**AGENDA
CITY OF CEDAR FALLS, IOWA
PLANNING AND ZONING COMMISSION MEETING
WEDNESDAY, JUNE 24, 2020
5:30 PM AT CITY HALL**

TO: Planning & Zoning Commission
FROM: Shane Graham, Economic Development Coordinator
Matt Tolan, EI, Civil Engineer II
DATE: June 18, 2020
SUBJECT: Wild Horse Ridge Preliminary Plat Amendment

TO: Planning & Zoning Commission
FROM: Shane Graham, Economic Development Coordinator
DATE: June 17, 2020
SUBJECT: Highway-1 District Site Plan Review

TO: Planning and Zoning Commission
FROM: Karen Howard, AICP, Planning & Community Services Manager
DATE: June 18, 2020
SUBJECT: MU District Site Plan for Immanuel Evangelical Lutheran Church parking lot expansion (Case #SP20-006)

PRELIMINARY PLAT

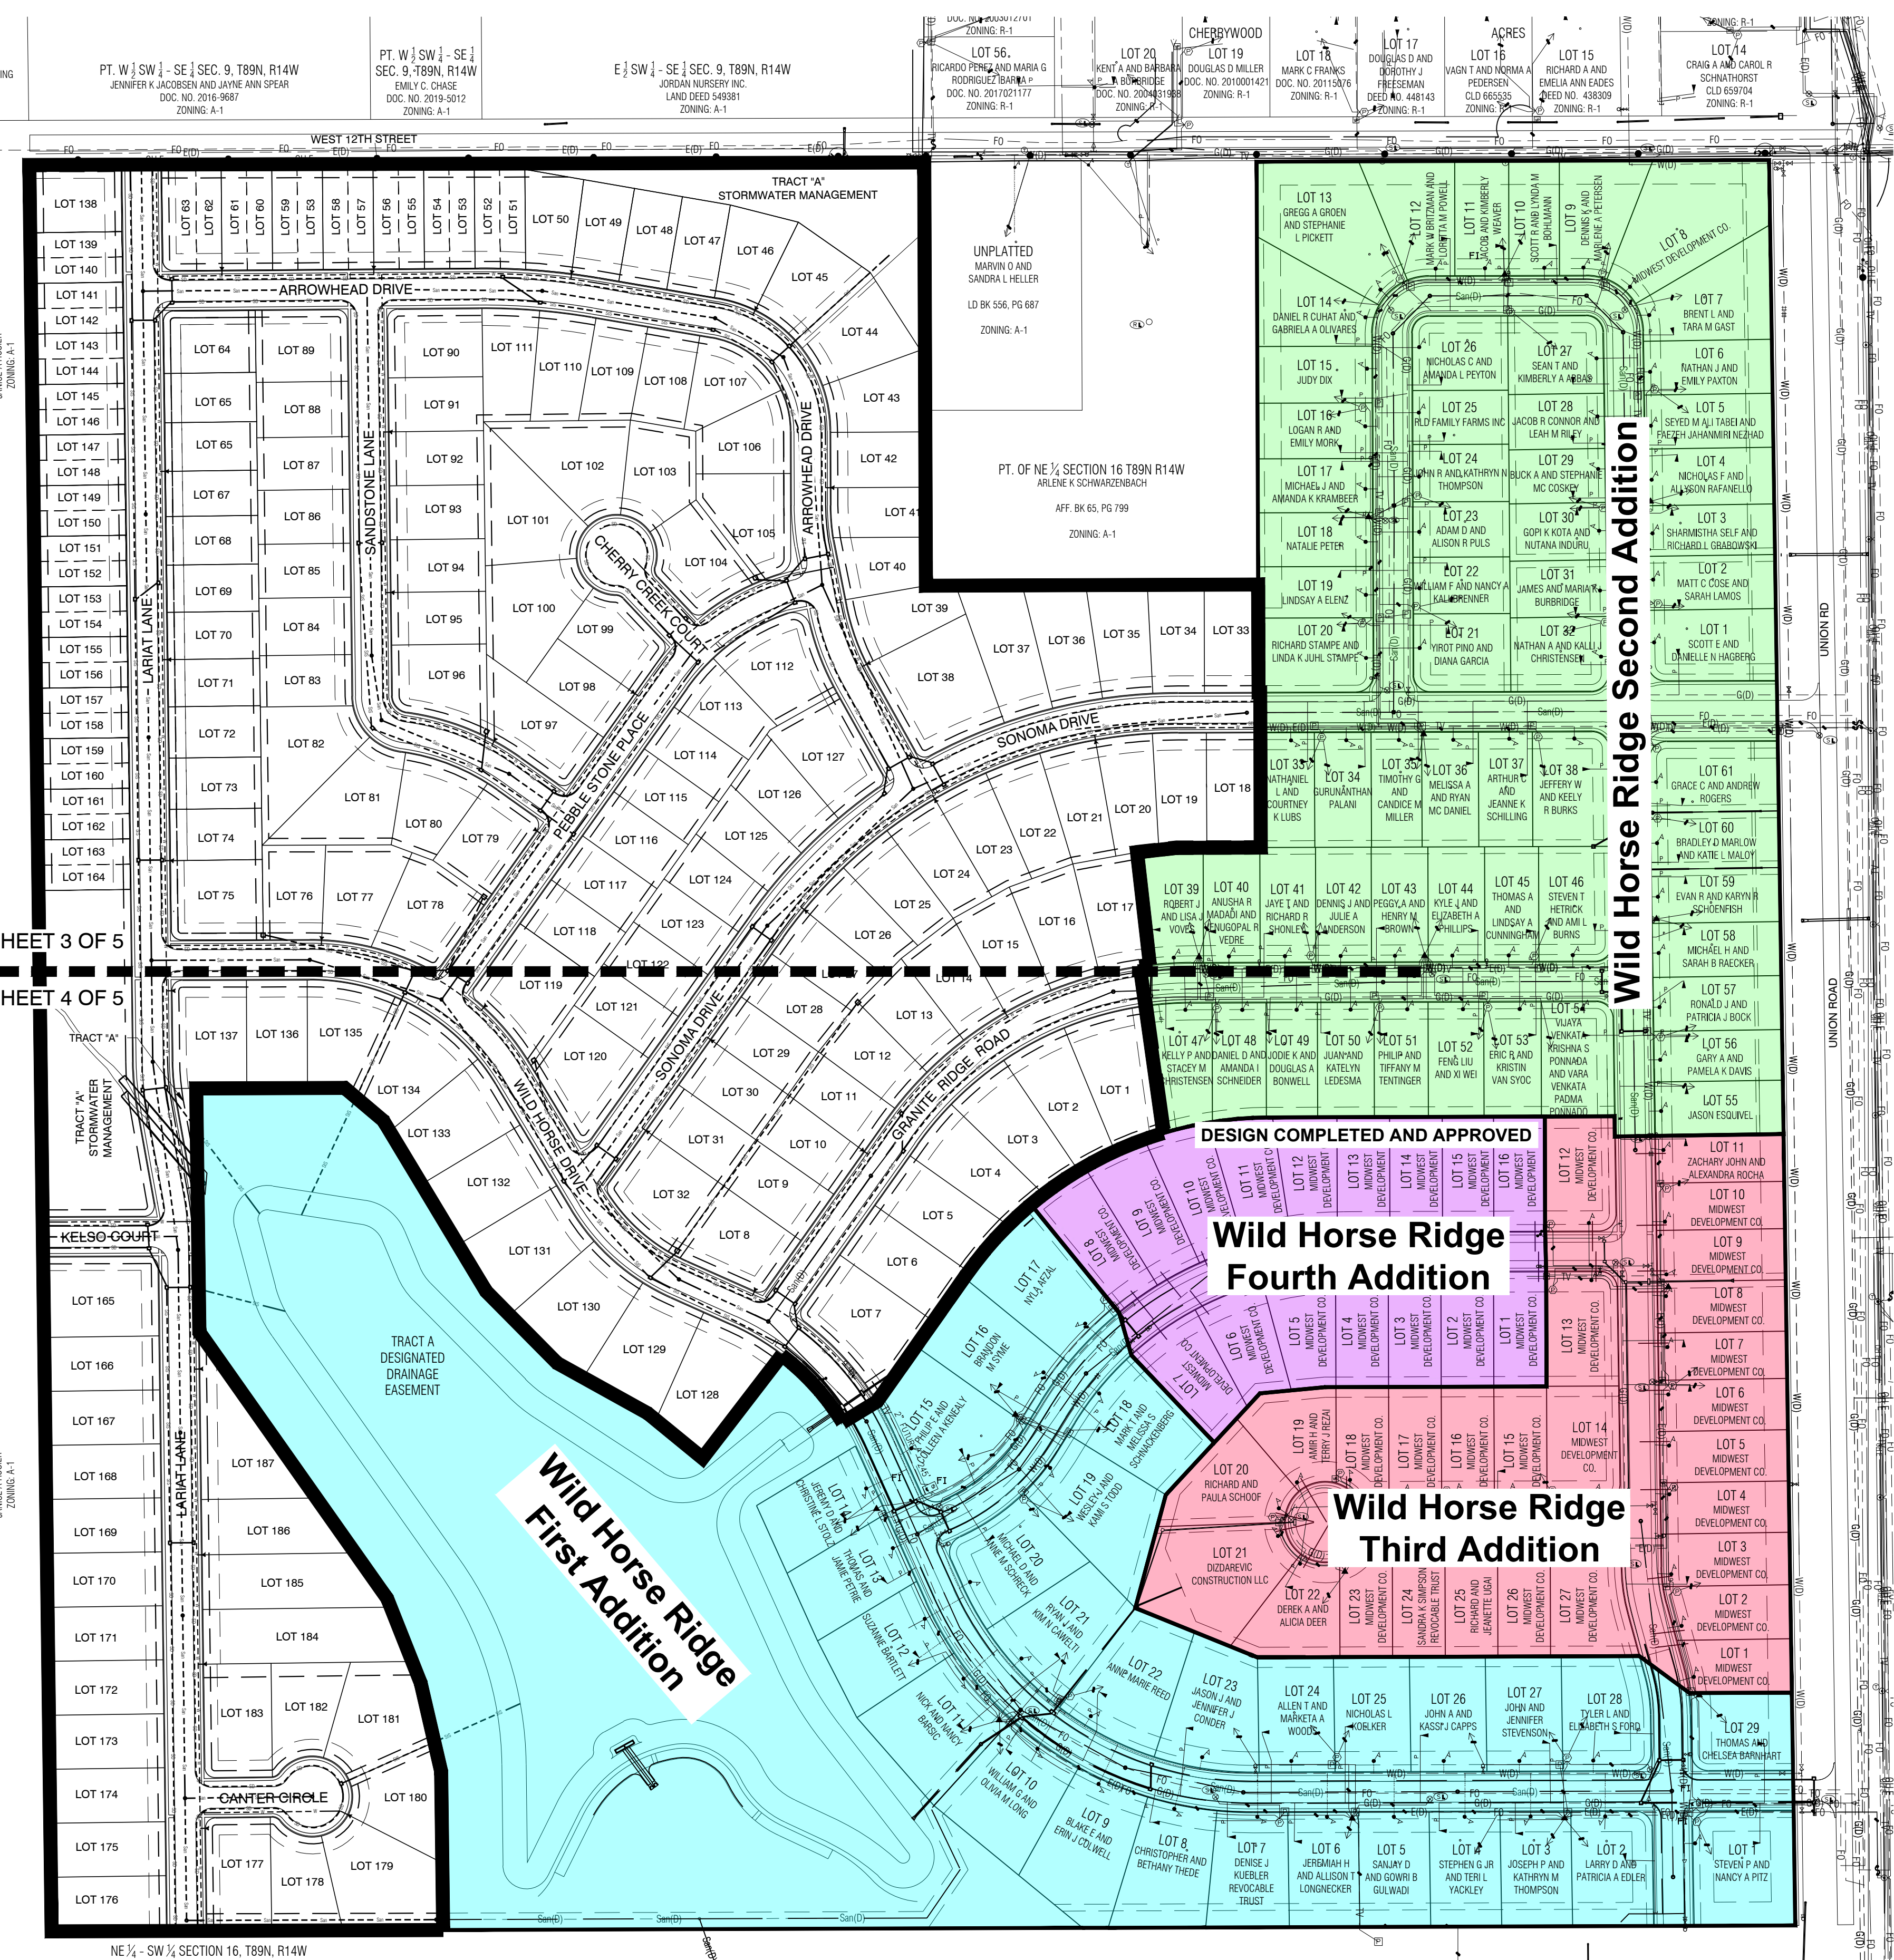
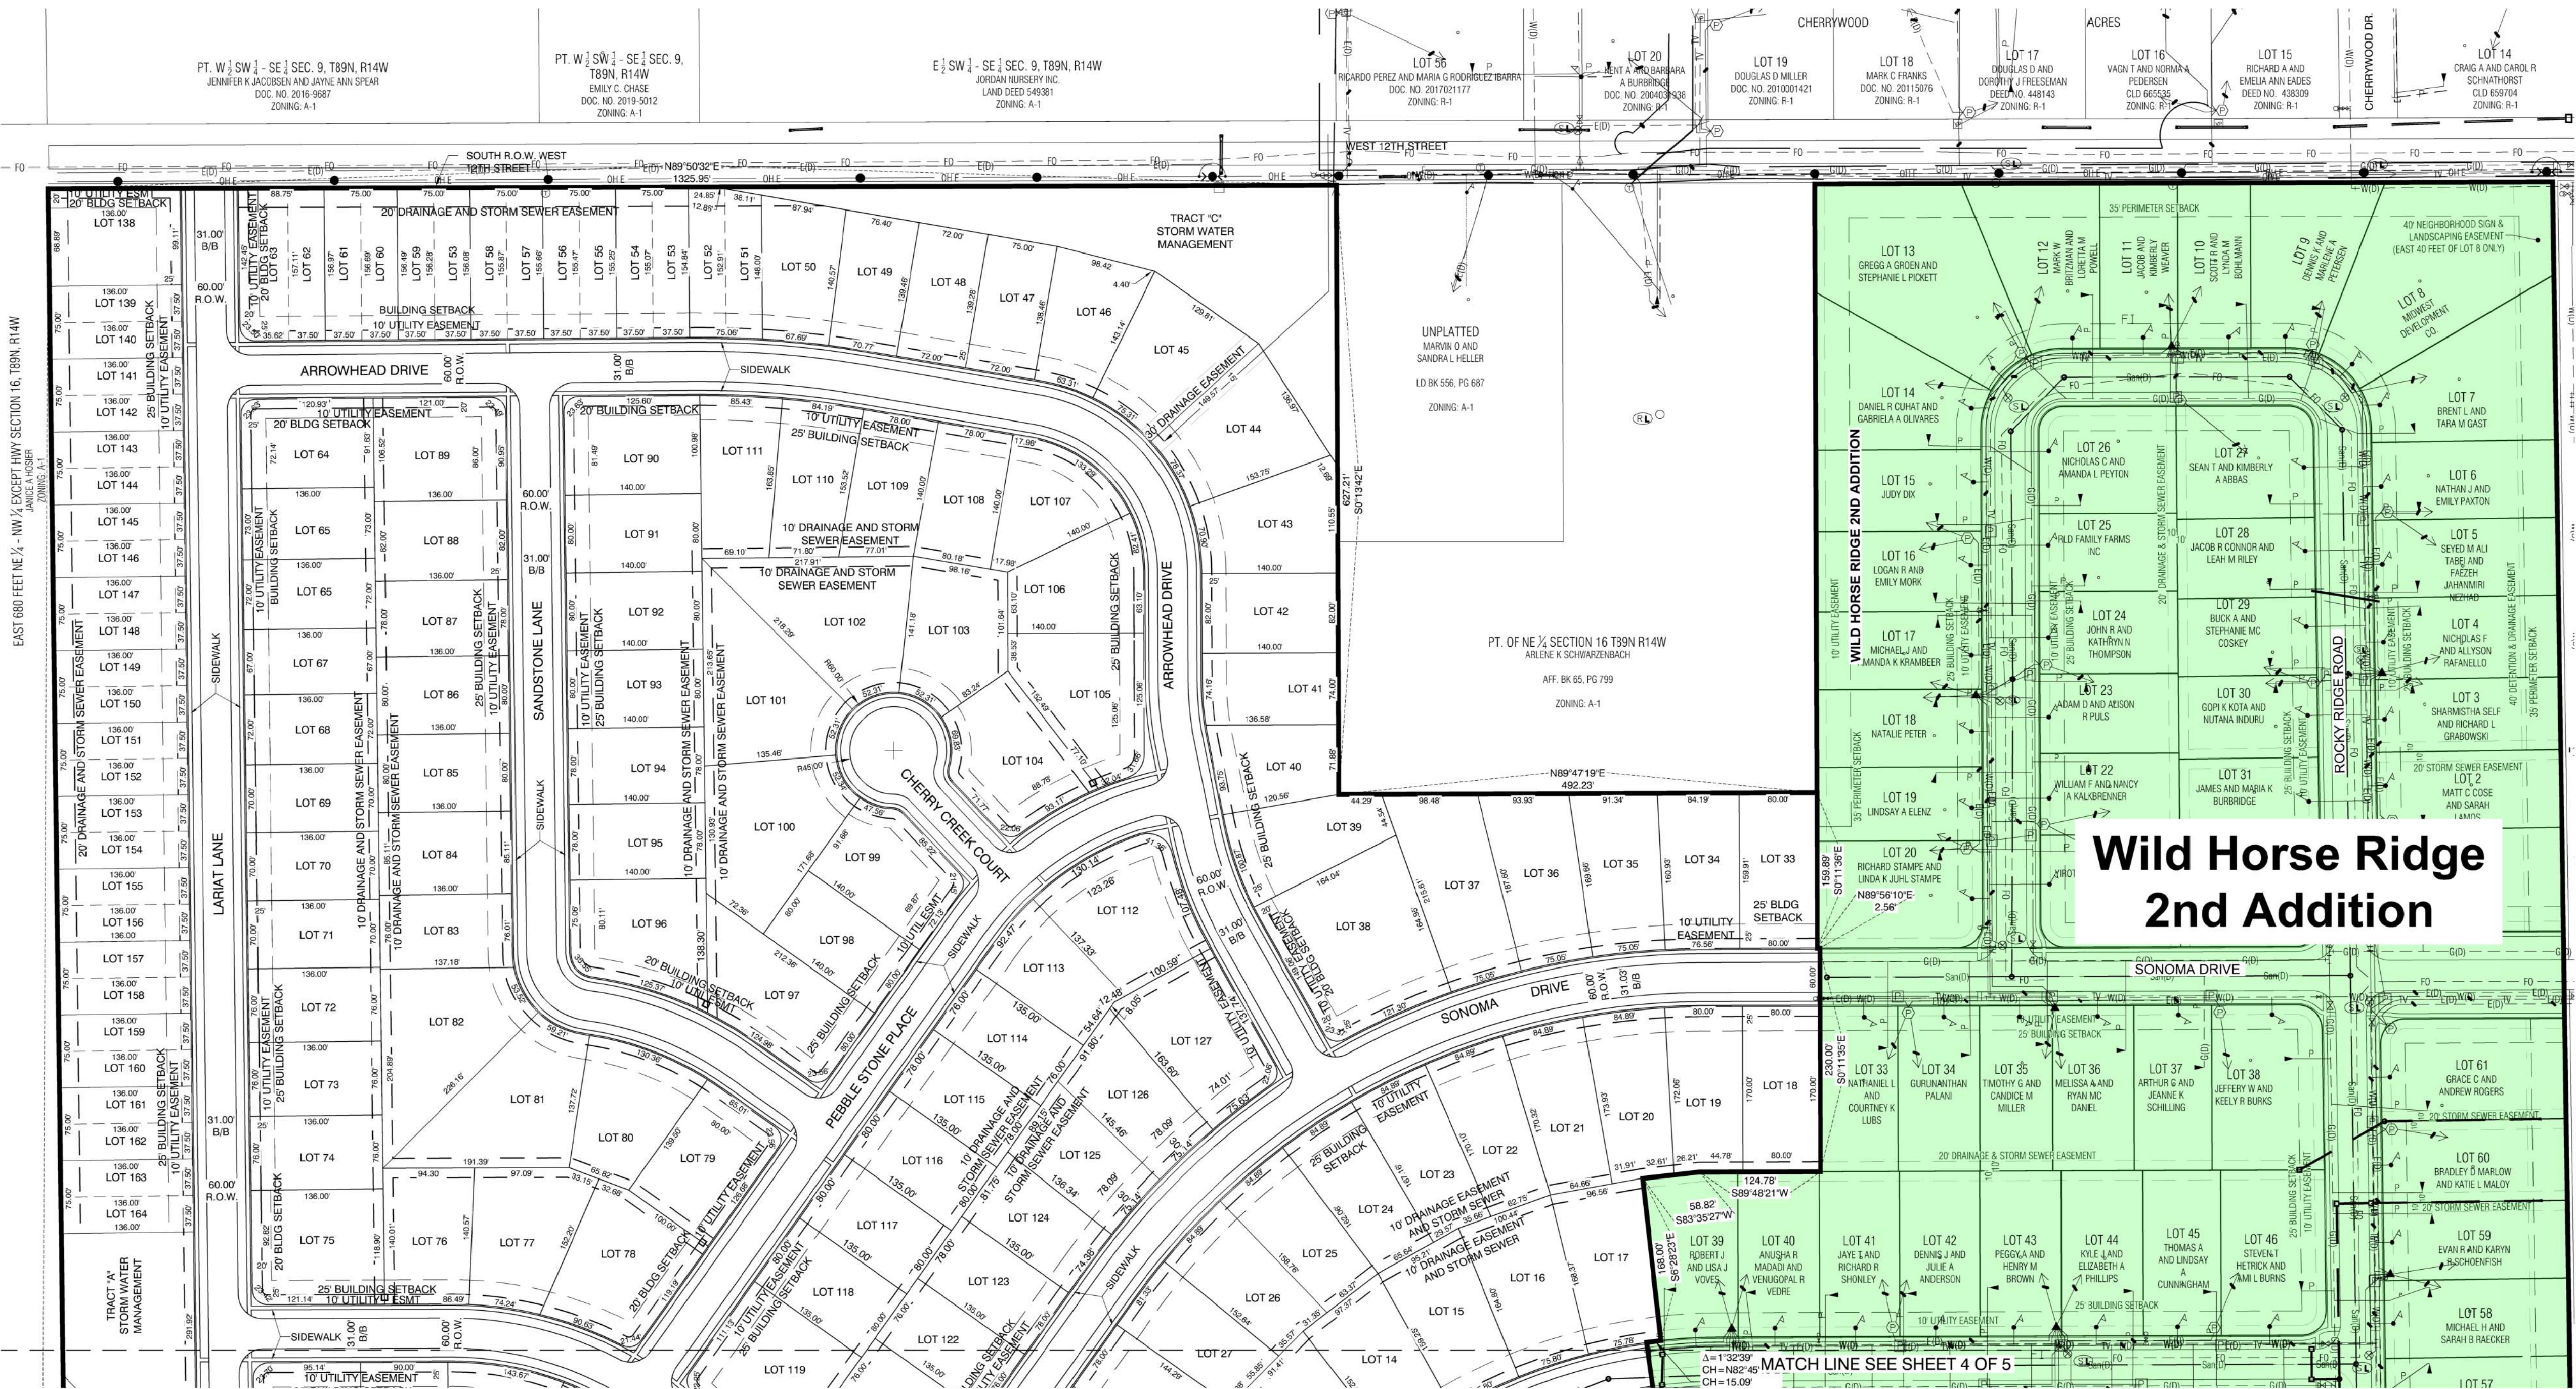
The developer has requested a change in the number of lots that were originally approved in the preliminary plat. They intend to construct a number of duplex units along the western and northern edge of the subdivision. The following table shows the proposed number of lots in the final five phases of this subdivision, and which addition the duplex lots will be located.

Along with this density change several new street layouts are being proposed. The original preliminary plat showed a cul-de-sac (Tyler Drive) located near the northwest corner of the plat. That is being removed, and Sandstone Lane will now be a through street that connects Arrowhead Drive to Pebble Stone Place. A smaller cul-de-sac, Cherry Creek Court, will be located just to the east of Sandstone Lane and will serve 6 lots. Also, Arrowhead Drive, which originally connected to W. 12th Street, now curves and connects with Lariat Lane, which does connect with W. 12th Street. Staff has worked with the developer to determine that two accesses from the subdivision to W. 12th Street is not needed. In addition, Granite Ridge Road, shown in the Fifth Addition, originally showed a small circle drive within the road, but this has been

The introduction of this amended preliminary plat is for discussion and public comment purposes. If the P&Z Commission is comfortable with the submitted preliminary plat, it is their decision on whether to forward for additional P&Z Commission review on 7/8 or to approve the amended preliminary plat on 6/24. The Community Development Department has reviewed this amended preliminary plat and would recommend approval.
